**Harbourside Shopping Centre redevelopment (SSD 7874)  
Response to Request for Additional Information**

**RE: Harbourside Shopping Centre Redevelopment, SSD 7874 - Response to Questions on Notice**

**Figure 1 SICEEP Project Boulevard Design Parameters**

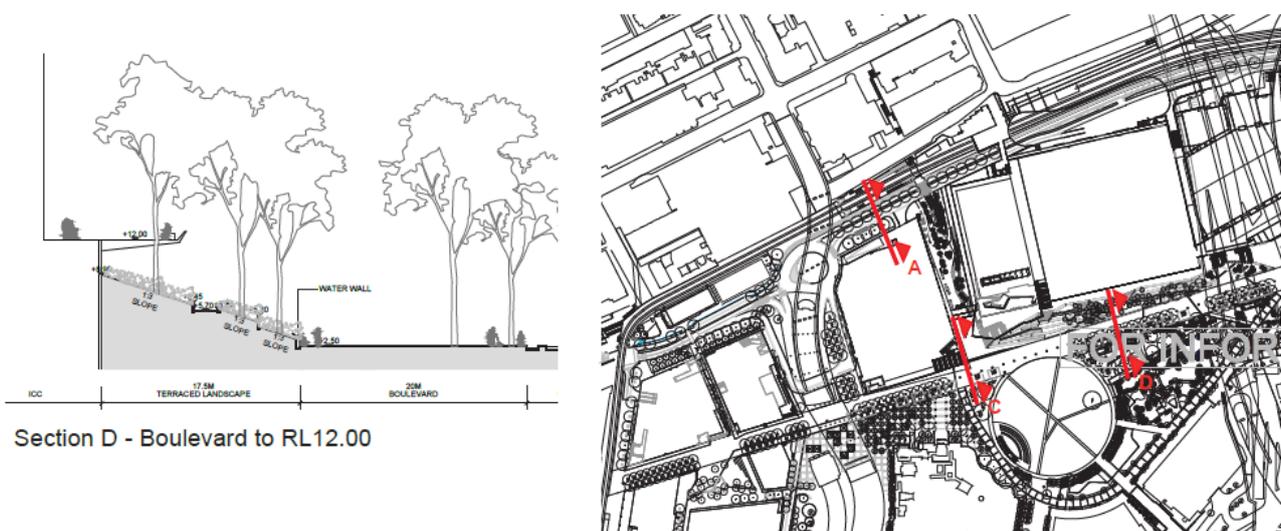
- *Pedestrian analysis supporting the proposed width of the promenade, including the proposal for a larger ferris wheel (currently before Council) and the impacts that might have on queuing and circulation space.*

The basis for this design width is also to align with the Boulevard to the south that was delivered and considered acceptable as part of the Sydney International Convention, Exhibition and Entertainment Precinct project (refer to **Figure 1**).

**Figure 4 Harbourside DA Site Boundary**

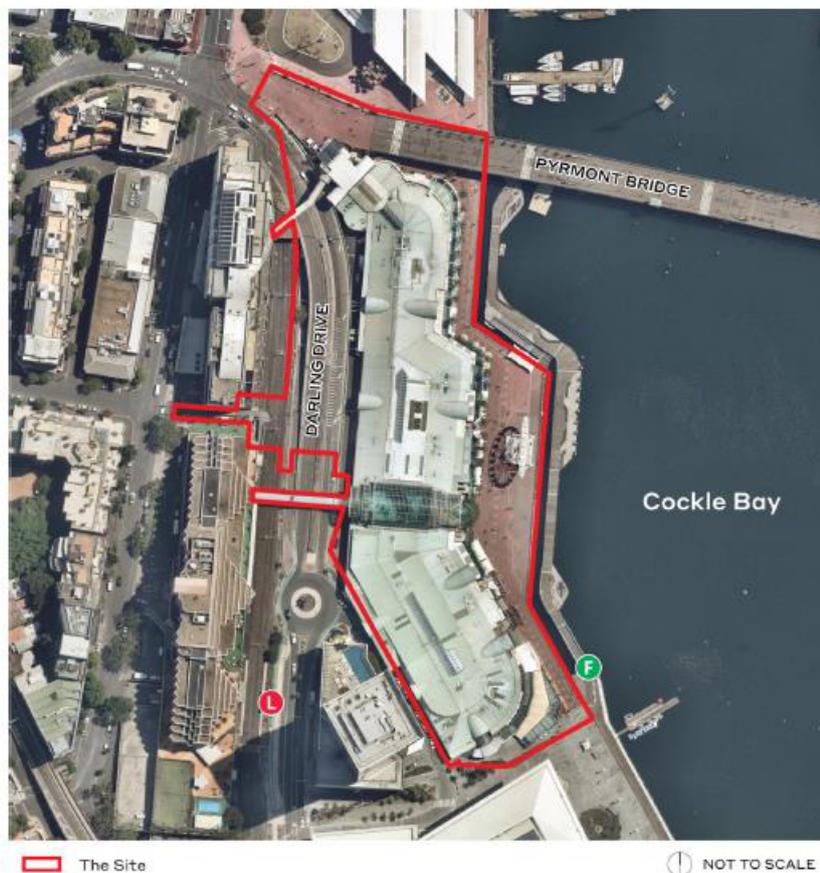
- *Confirmation of the legal definition of the site being considered for this application.*

The plan and correspondence provided at **Attachment B** and **C** respectively also provide confirmation of the legal definition of the site to which the development application relates to – which is generally illustrated below also in **Figure 4**. As clear throughout the planning documentation, the site boundary is broader than the land to which Mirvac has a real property interest in, incorporating land to which Mirvac is proposing public domain works.

Figure 10: Existing Promenade Circulation Space at Ferris Wheel (source: Google Maps)

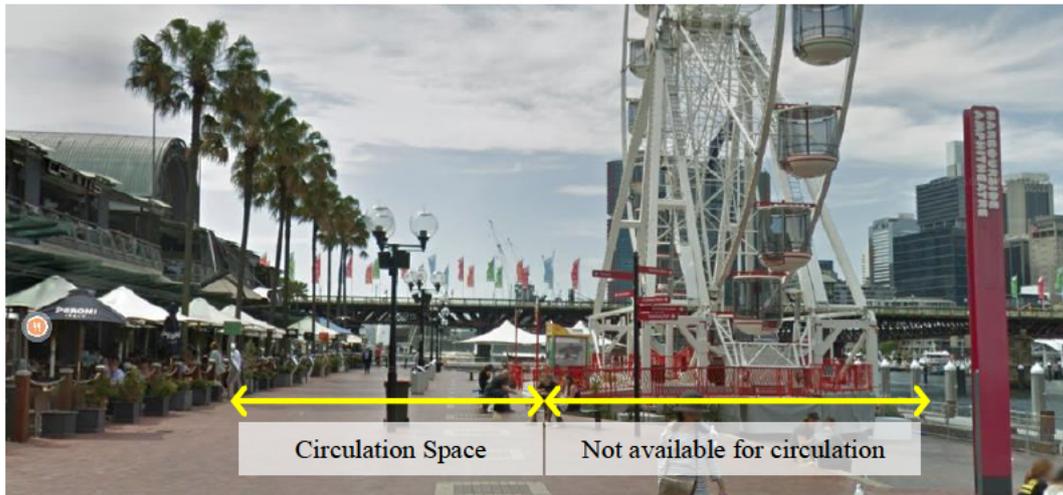
As we interpret the comment, the key issue is that IPC requests:

In all promenade sections, the proposed layout increases the amount of space for pedestrian circulation. The middle section of the existing promenade is the widest section of the entire area but as a functional circulation space, it is compromised by the elevation change and the existing footprint of the Ferris wheel, which effectively blocks the lower level from use.

**Annexure – Plan SK-006**

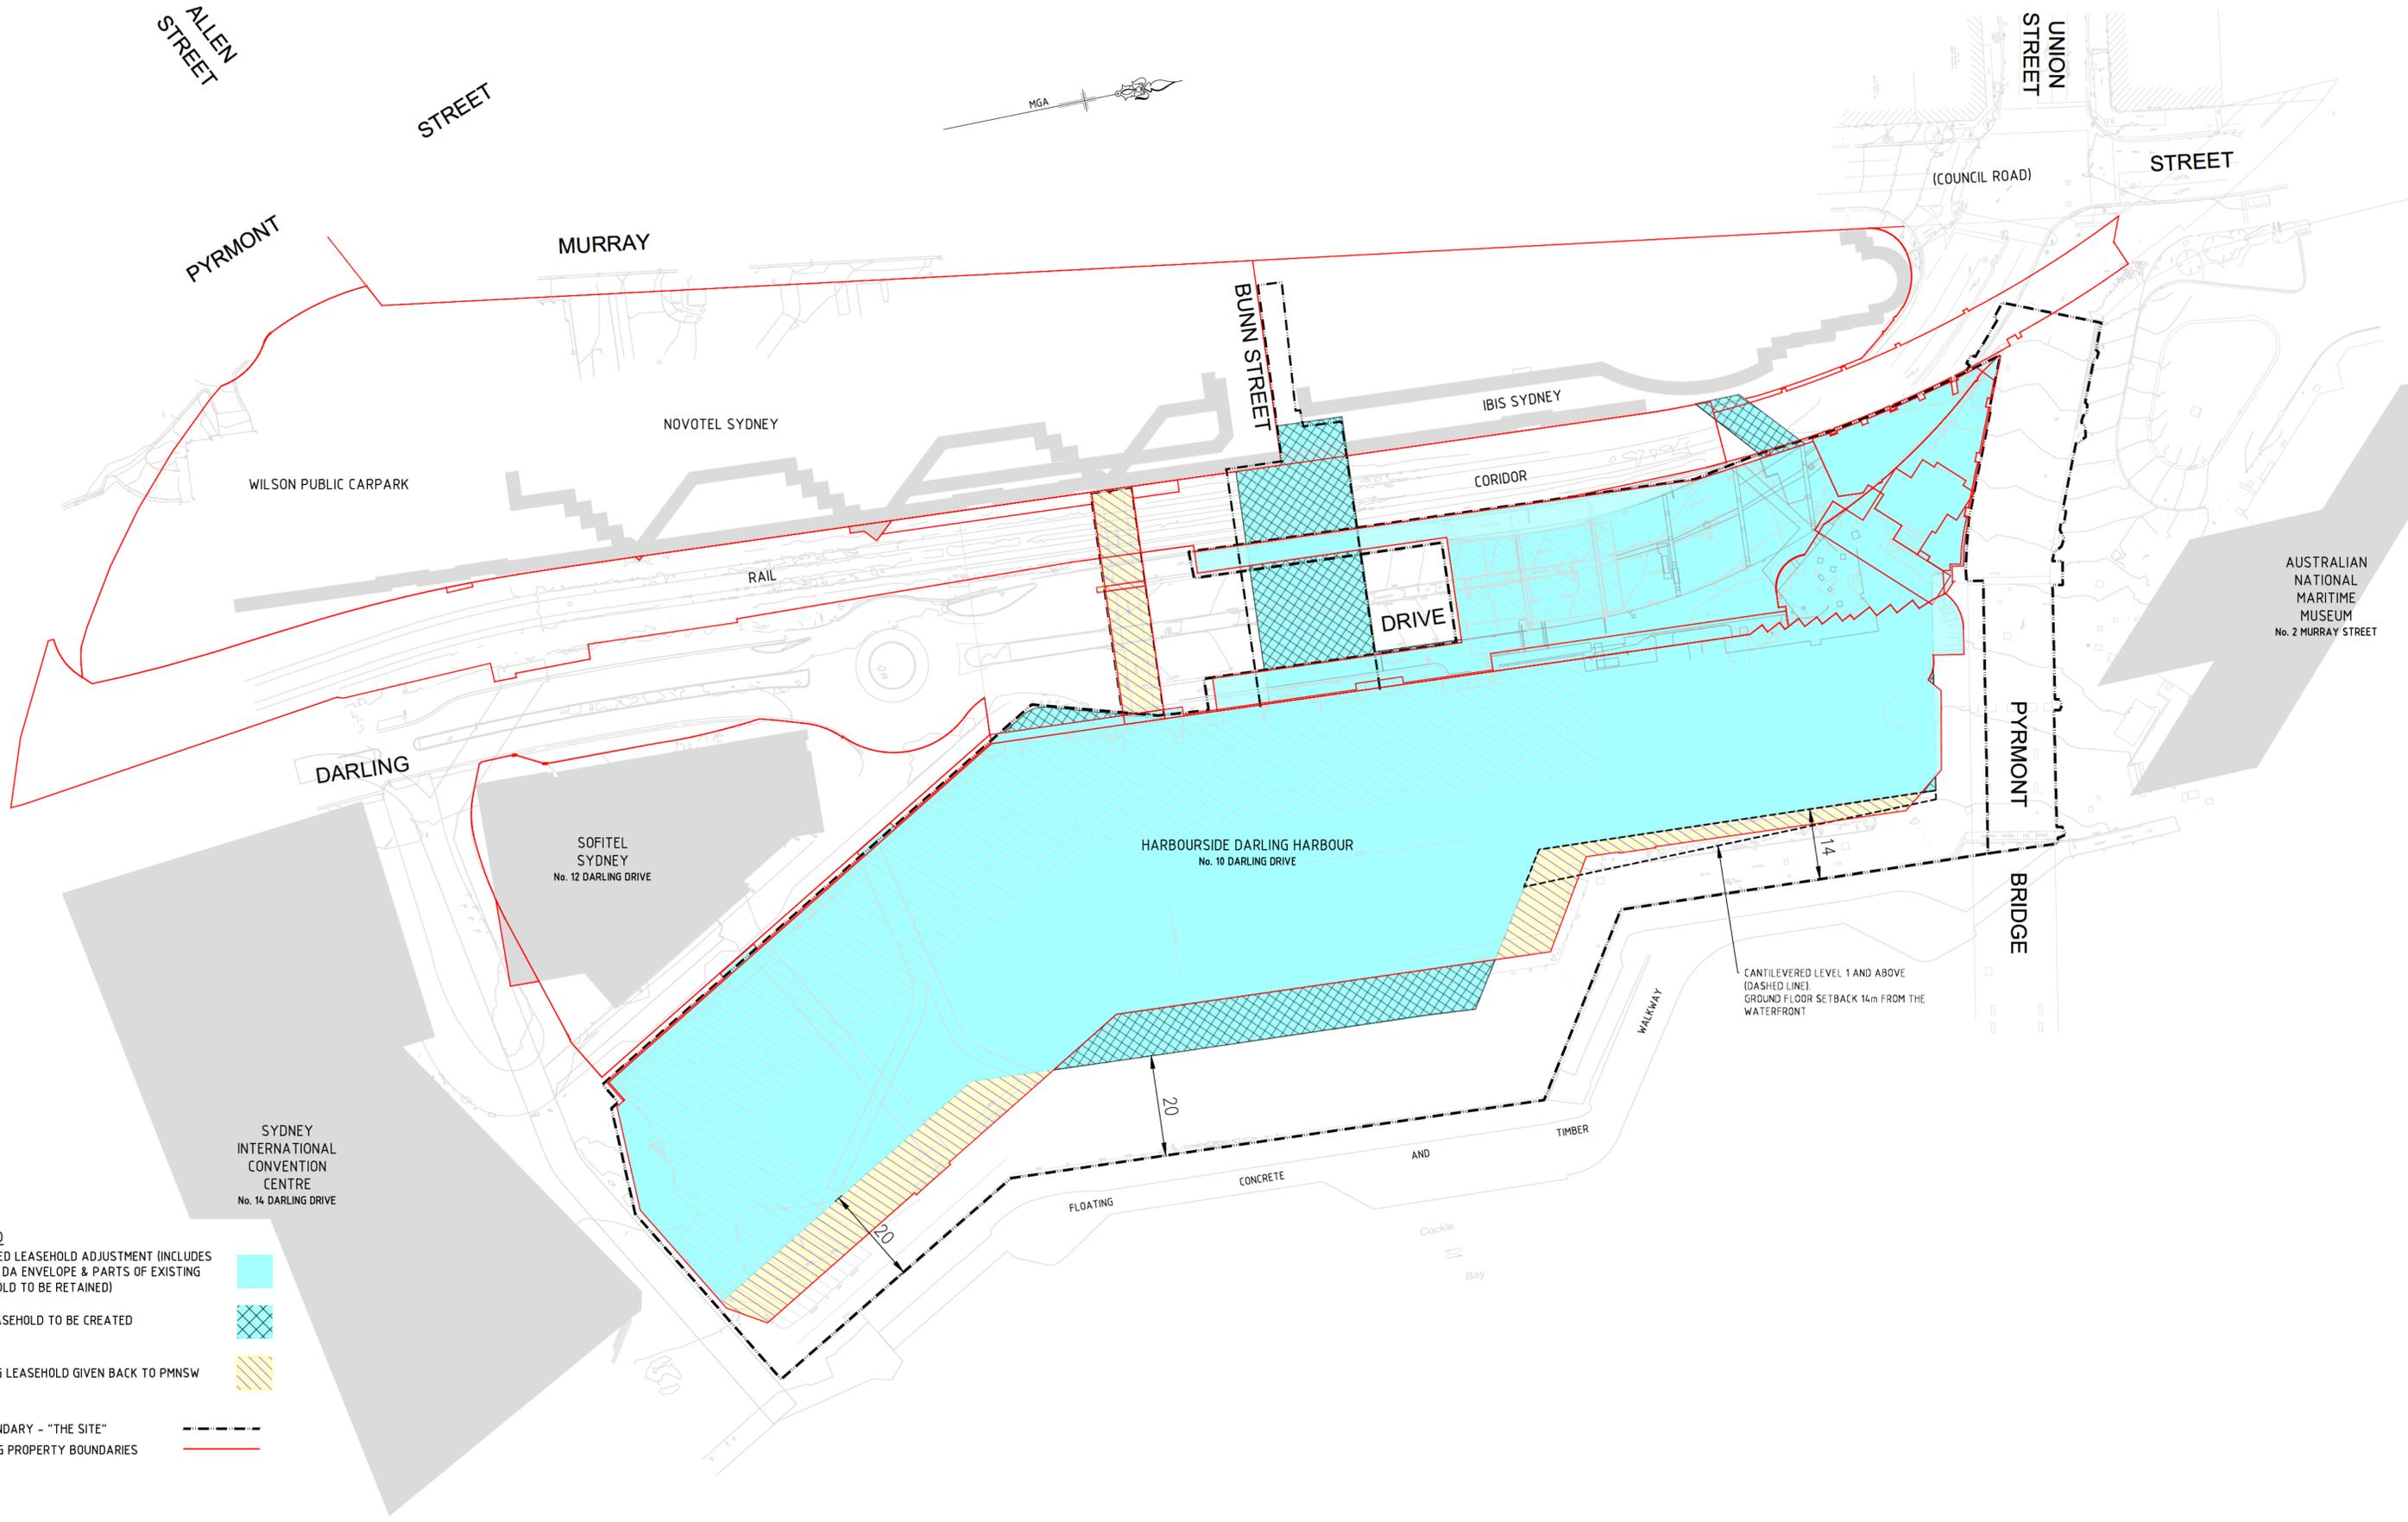
- A plan reflecting the current leasehold boundaries and any proposed amendments to the leasehold boundaries.
- Confirmation of the legal definition of the site being considered for this application.

However, our client's surveyors have prepared Plan SK-006 attached to this letter, showing:

- the current lots subject to the Existing Lease (and as shown as such in Plan SK-006) are Lots 1 to 10, 12 to 15 and 17 in Deposited Plan 776815 (“**Current Lots**”), and Place Management NSW (formerly Sydney Harbour Foreshore Authority) is the registered proprietor of all Current Lots; and
- part areas of the following additional lots fall within the area shaded yellow and hatched in Plan SK-006 and are required for the leasehold of the completed redevelopment:
  - Lot 2015 in Deposited Plan 1234971;
  - Lot 1002 in Deposited Plan 844561; and
  - Lot 300 in Deposited Plan 836419,(together the “**Additional Lots**”). Place Management NSW is the registered proprietor of each Additional Lot.

that are contained within the ‘DA Boundary – “The Site”’ marked in Plan SK-006. This includes both the areas required as leasehold after completion of the redevelopment, and surrounding areas that are to be handed back to or retained by Place Management NSW.

Figure 1 – Jan 2020 Traffic Survey Locations

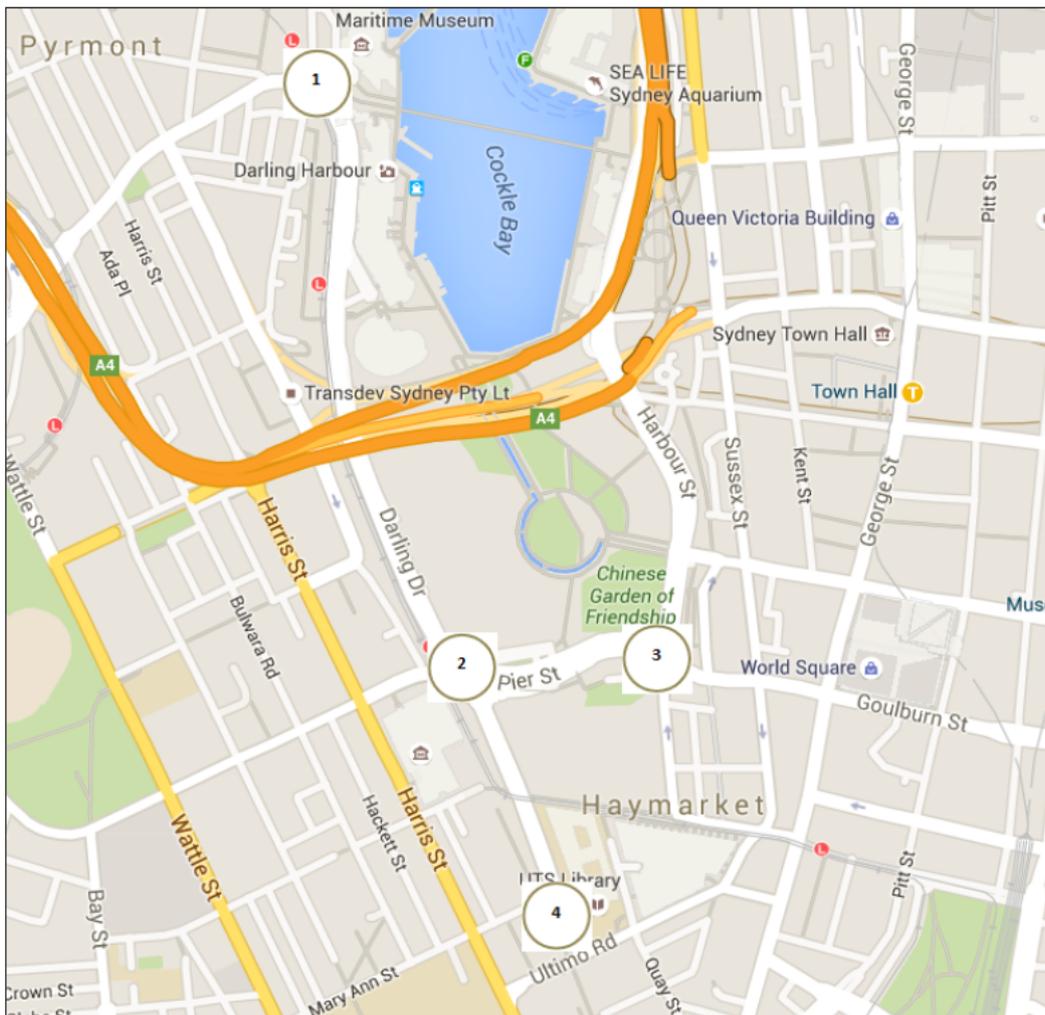
- *Confirmation as to how the traffic assessment addressed commercial car parking provision for the site, currently under separate arrangement with the Novotel.*

In response to this query, Arcadis can confirm that the existing 255 car parking spaces that are located under the Novotel hotel, which are currently leased by Mirvac and are to be retained for use for the future retail and commercial components of the development have been considered in the existing baseline traffic modelling and assessment.

The existing baseline traffic model was developed using traffic survey data of the intersections in the vicinity of the development four key intersections (refer to **Figure 1** for locations) expected to be impacted by the development, including:
